Re: Turkey Point Units 3 and 4
Docket Nos. 50-250 and 50-251
ECCS Reevaluation
Supplemental Information

Re: Turkey Point Units 3 and 4
Additional ECCS Information

FIGURE 1

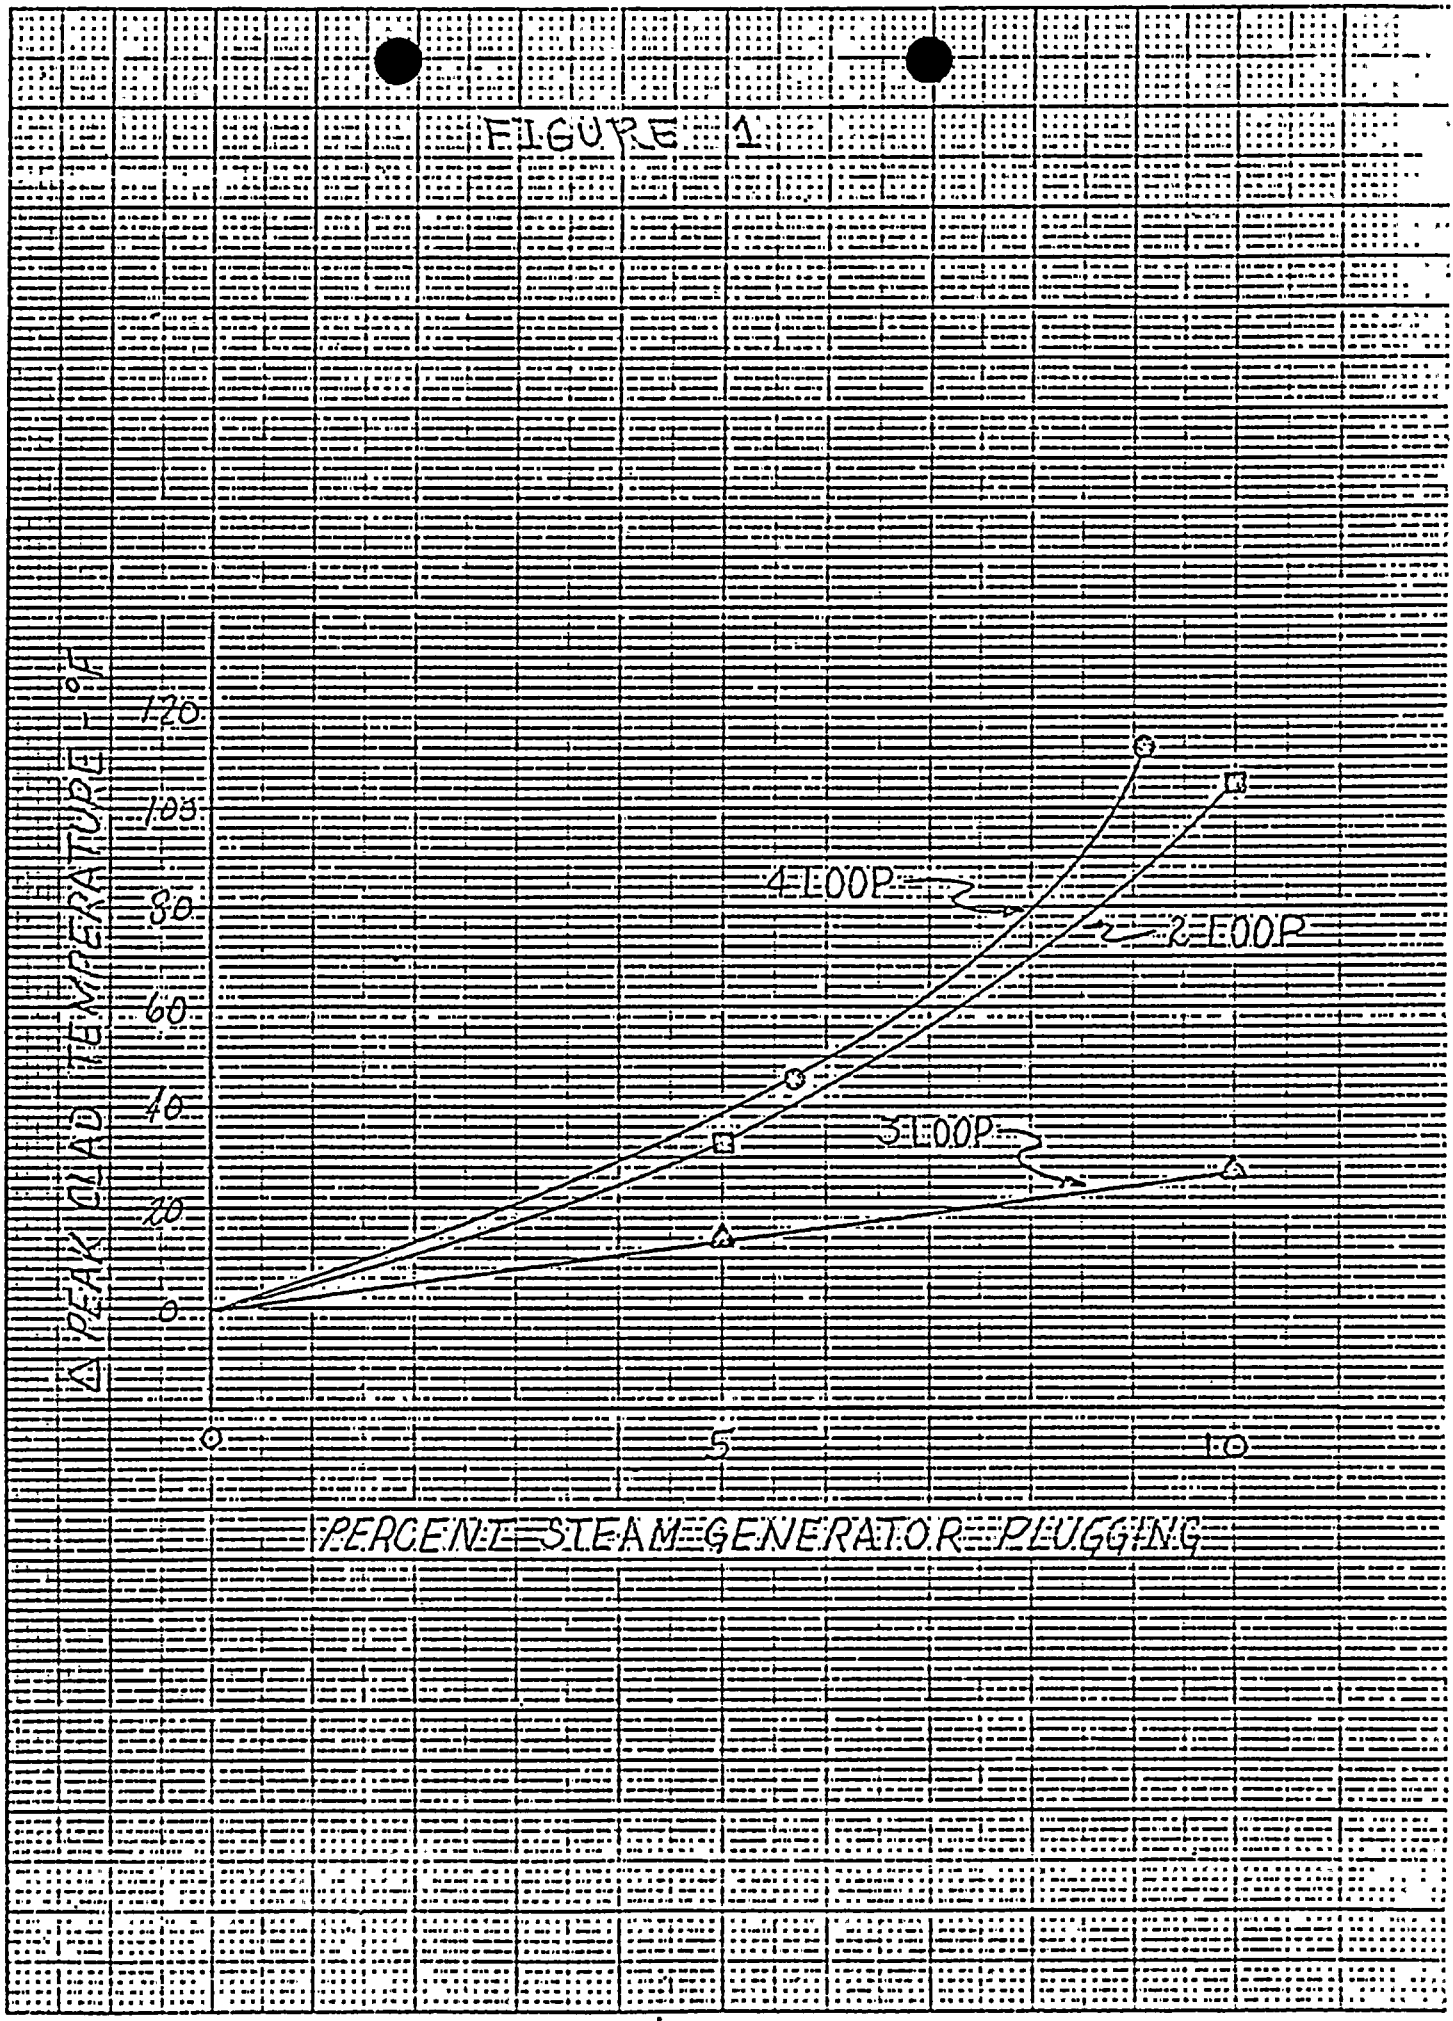
QUESTION: Justify that the peak clad temperatures corresponding to different percentages of plugged steam generator tubes can be obtained by a linear interpolation, and submit a basis for the dependence of F_q on steam generator plugging.

ANSWER: Sensitivity studies were performed by Westinghouse in the early part of 1976 to determine, on a generic basis, the effect of plugged steam generator tubes on peak clad temperature (PCT) calculated during a LOCA. Three sets of runs were made, 1 each for a 2 loop plant, a 3 loop plant, and a 4 loop plant. The results were summarized and presented at an ACRS ECCS Subcommittee meeting. Plots of the results are shown in Figure 1. Figure 1 shows that the curves of ΔPCT versus percent tube plugging are concave upward, which means that linearly interpolating between any two plugging levels results in a higher, or conservative, value of ΔPCT .

FIGURE 1A ACCUMULATOR WATER VOLUME, 825 FT³

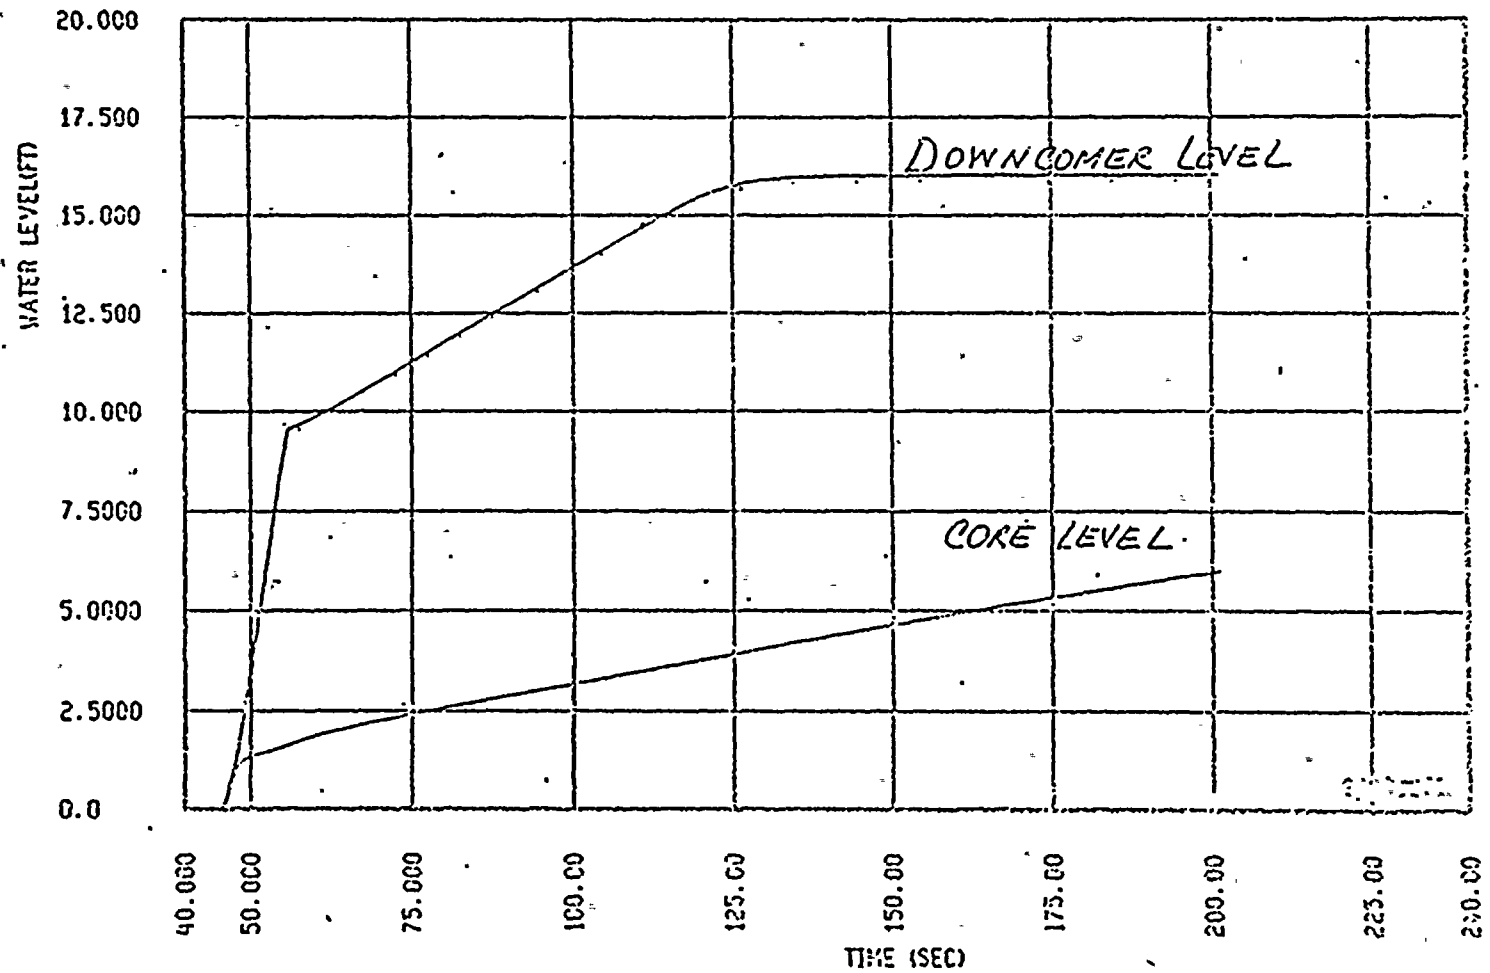
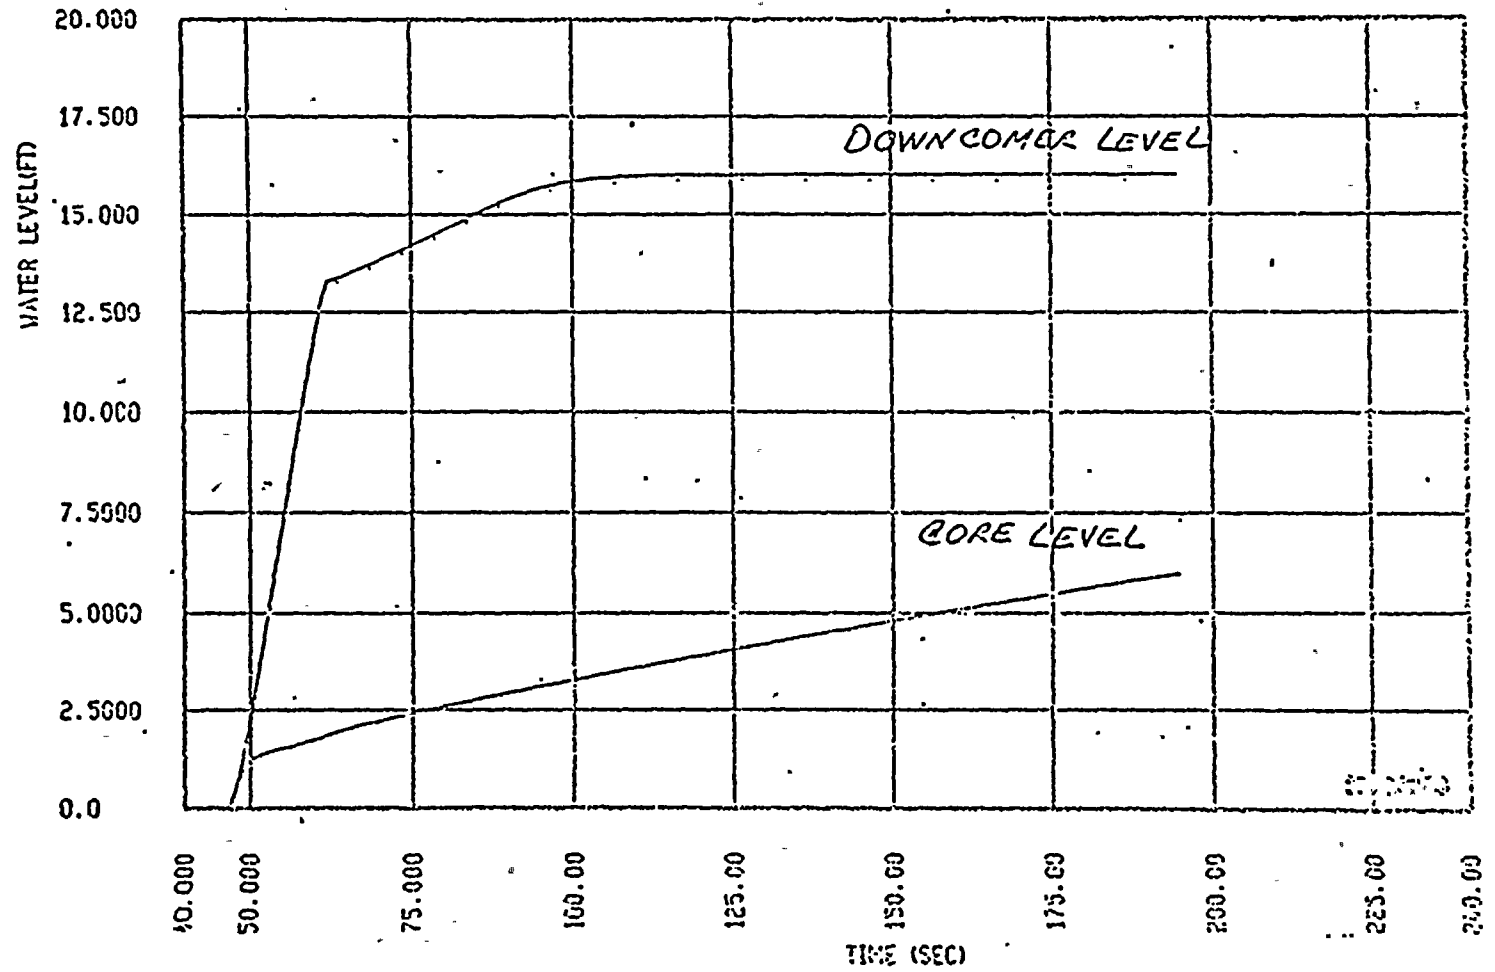
QUESTION: Submit the Westinghouse ECCS analyses which show that the decrease in accumulator water volume from 875 cubic feet to 825 cubic feet corresponds to 36°F rise in PCT.

The effectiveness of accumulators can be studied by inspecting Figures 1a and 1b, which are the downcomer water level and core water level plots, and Figures 2a and 2B, which are the core reflood water inlet velocity plots. The optimum accumulator water volume, based on previous studies, is generally a value that results in the downcomer being "almost" full when the accumulators empty.

From Figure 1a, when the accumulators empty, the downcomer height is about 9.5 feet for an initial water volume of 825 cubic feet per tank. Figure 1b indicates that increasing the initial water volume to 875 cubic feet per tank results in the downcomer being filled to 13.3 feet when the accumulators empty. This difference in accumulator performance during the accident results in a decrease in PCT from 2194°F for the core using 825 cubic feet initial accumulator water volume per tank to 2158°F for the case using 875 cubic feet.
